St. Bernard Parish Library
Construction Documents Review by Staff
July 13, 2020

Additional Floor Outlets

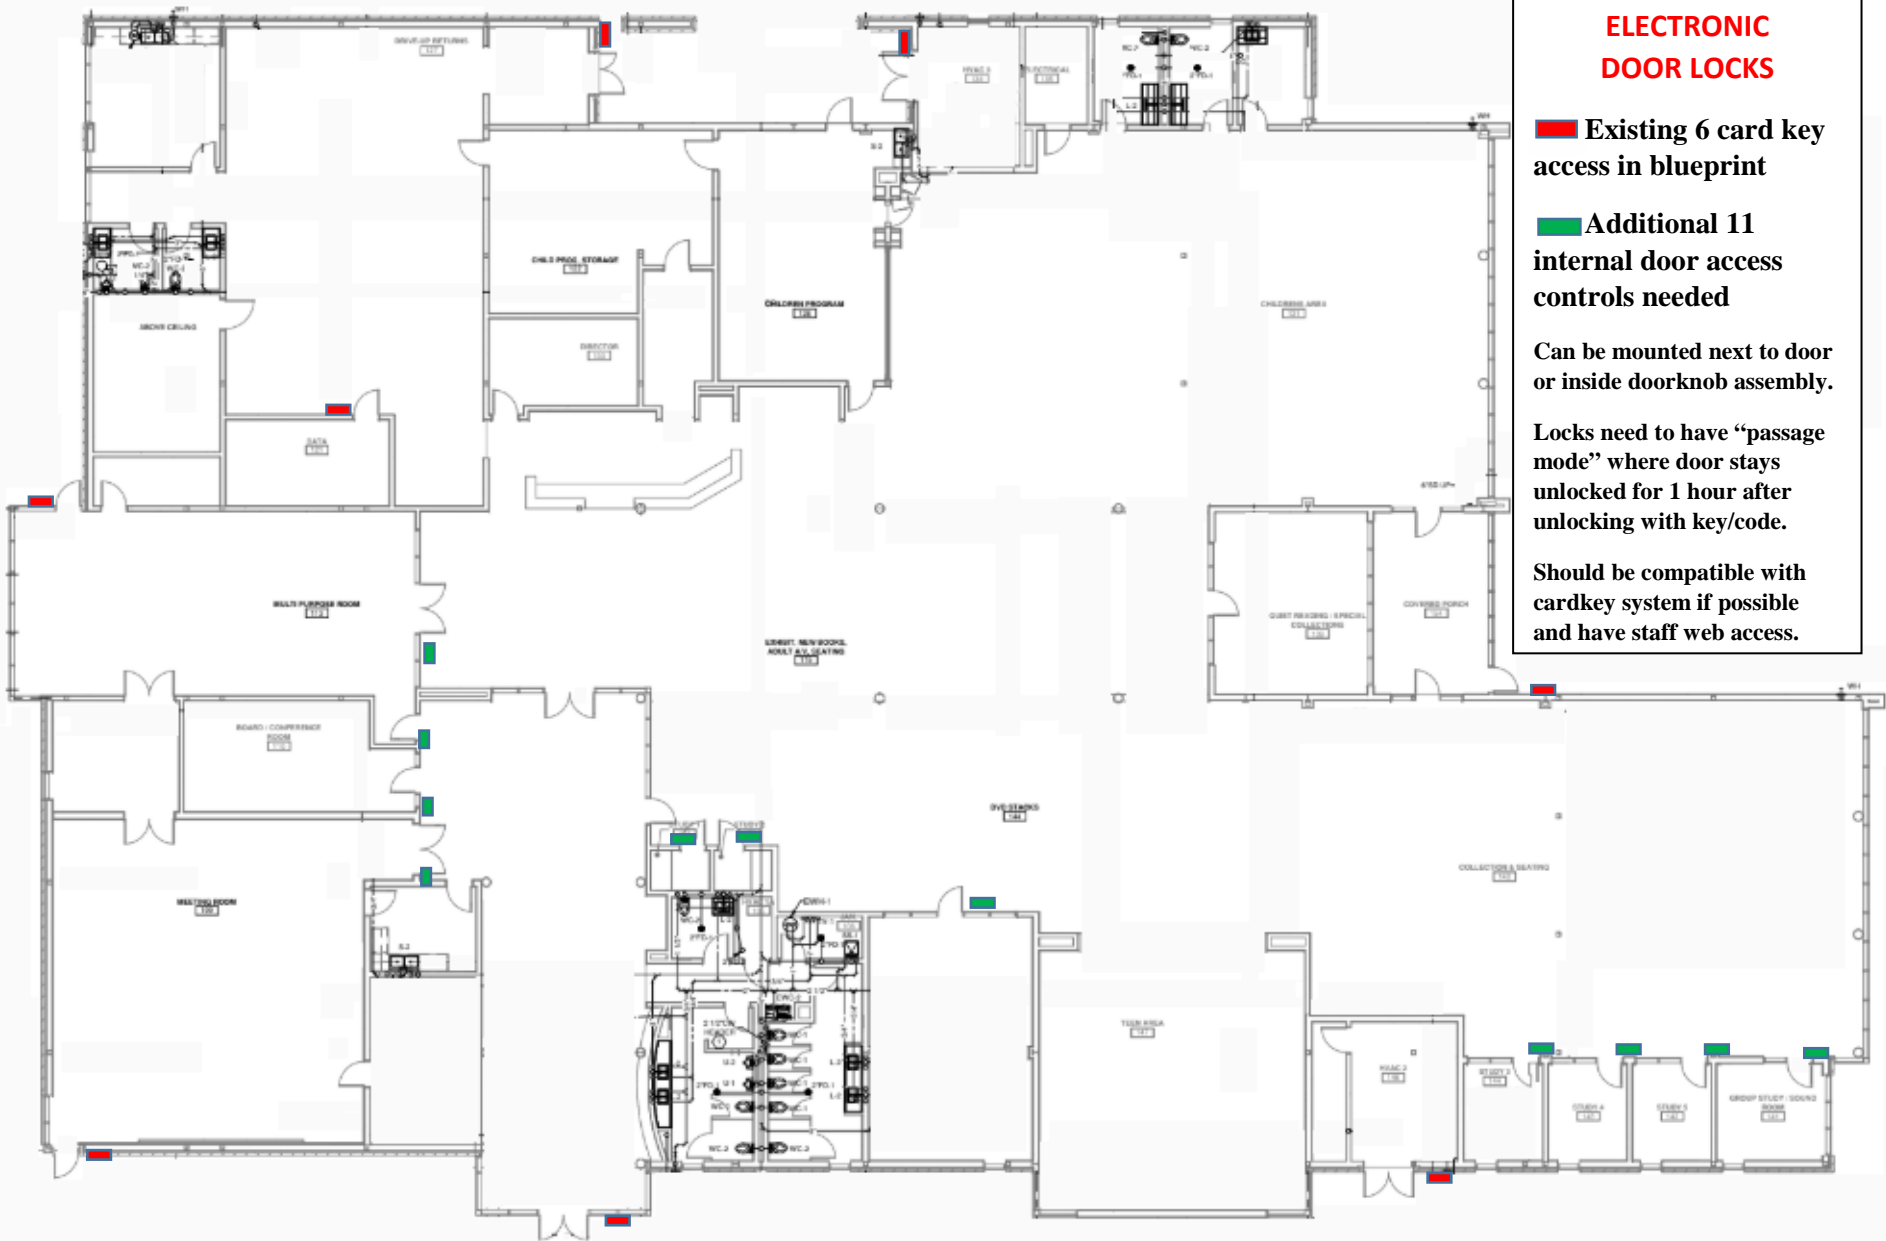
8. **Other Lighting and Power concerns.** While automatic lights are an economical way to conserve, there also needs to be a way for the staff to override and turn the lights off, especially near closing time, when we wish for the patrons to “come out of the stacks”. We have identified a location in the staff area near the circulation desk for this purpose. Reviewing the electrical diagram shows that not all chairs have the needed floor outlets. We have identified two locations where the laptop chairs do not have the needed power receptacle.

Laptop chairs need floor power outlets

**ELECTRONIC
DOOR LOCKS**

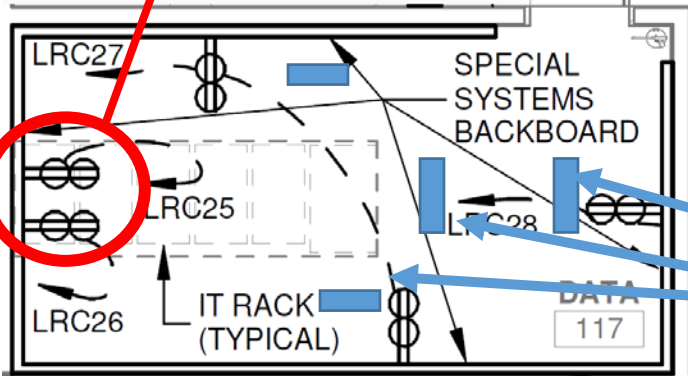
9. **Electronic door locks.** Since the new library now has several study rooms, a conference room, and meeting rooms (possibly used after hours), there needs to be some way to lock rooms that should not be used. Traditional locks with metal keys get lost and/or stolen and duplicated, so it is strongly suggested that some sort of electronic means to open the door in addition to a traditional key for staff to use in power outages, be implemented. There are many time-lock, card key, keypad, and hotel-room systems on the market. These systems usually require Ethernet or some control wiring to be strung to either the inside of each door or to the door jamb. Whatever system is used, it would be beneficial that the system offer some sort of “passage” mode, where once the door is unlocked for a guest, it will stay unlocked for a certain time period (say 30 minutes) without having to reuse the key.

Existing 6 card key access in blueprint

Additional 11 internal door access controls needed

Can be mounted next to door or inside doorknob assembly.

Locks need to have “passage mode” where door stays unlocked for 1 hour after unlocking with key/code.

Should be compatible with cardkey system if possible and have staff web access.

DATA ROOM and RACK WIRING

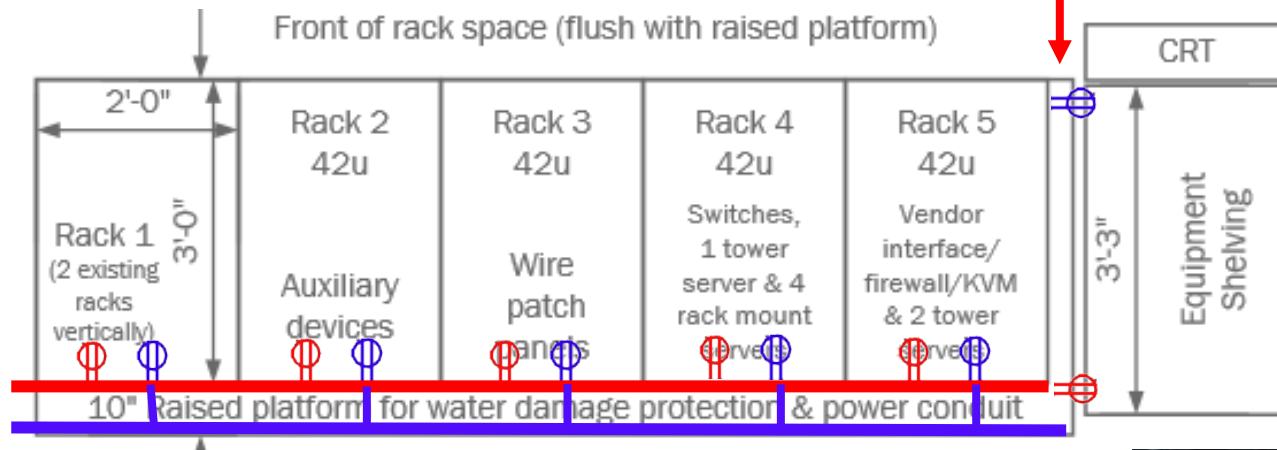
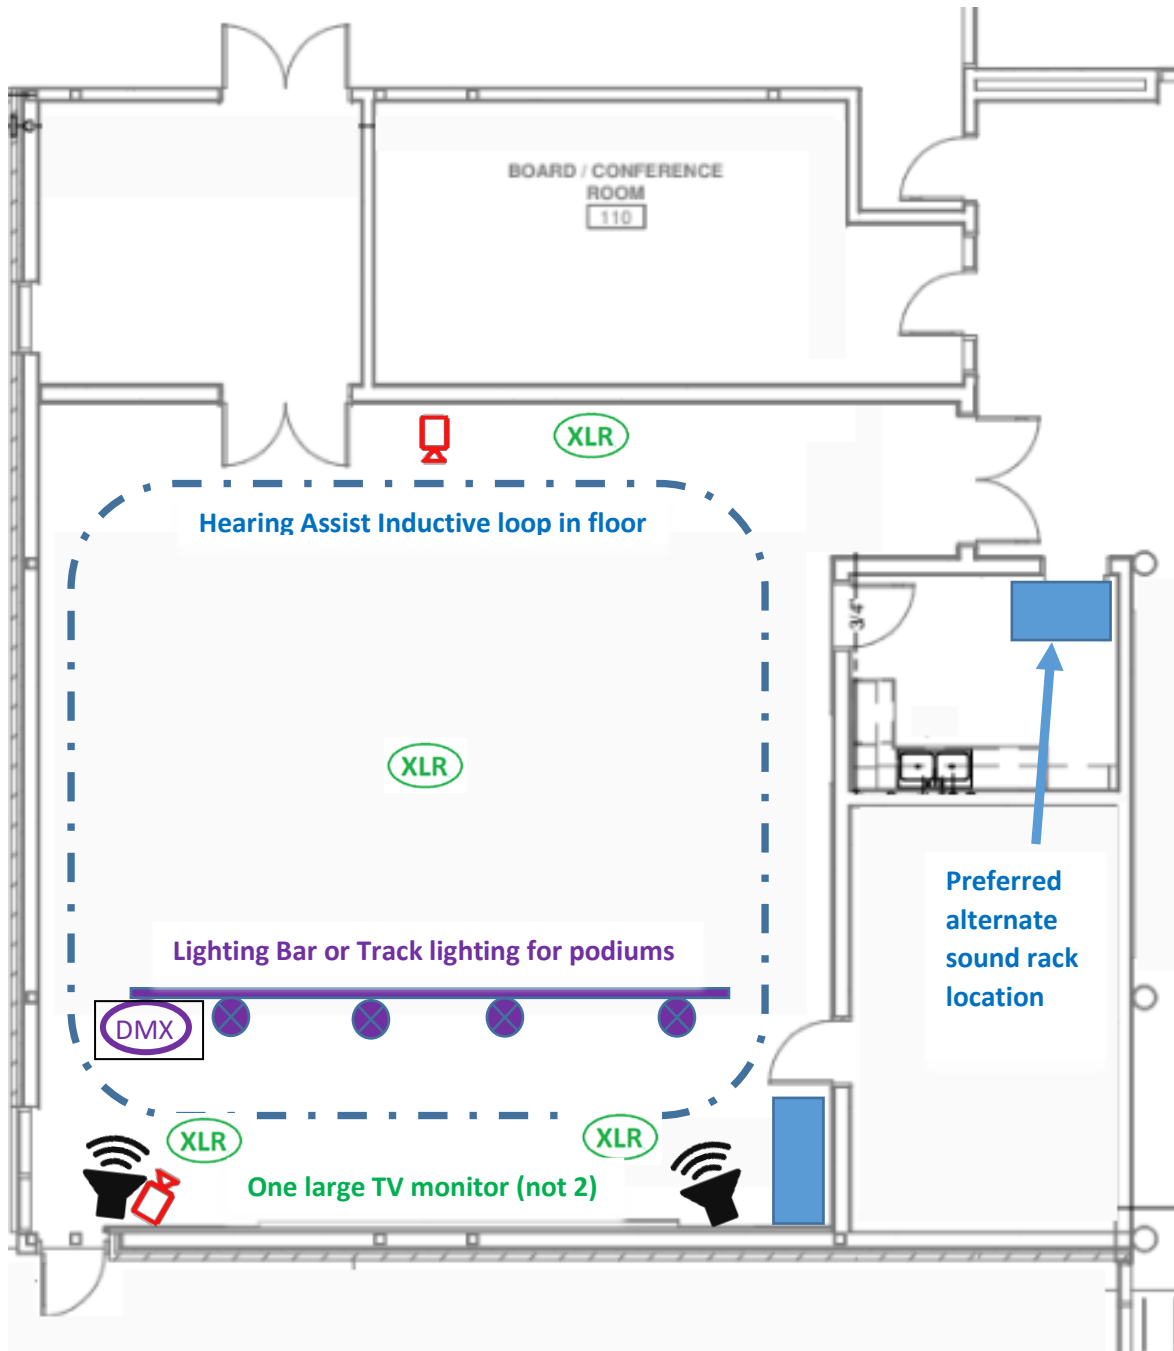
10. **Data room changes.** The power layout for the racks is clumsy and inadequate. The existing plans would require long cords from each rack to be strung along the other racks to reach the outlets shown on the wall. In the original design meeting with the architects, we discussed having an offset on the racks in the back of the raised pedestal to route power to each rack individually, which is shown. Our servers have dual power supplies and need two different power circuits in each rack in case one circuit fails. In addition, there needs to be some sort of ceiling-mounted raceway bracket system mounted between the racks and the north, east, and west walls, so that wiring from wall-mounted staff and vendor equipment can reach without being a tripping hazard (in lieu of a raised floor).

Wall-mounted outlets for racks should NOT be used. Instead, see images below.

Ceiling-mount raceway brackets

Outlets in shelving wall for CRT and Aux Equipment Shelf

2 Separate power circuits (marked red & blue) for power fail-over in each rack located inside the bottom rear
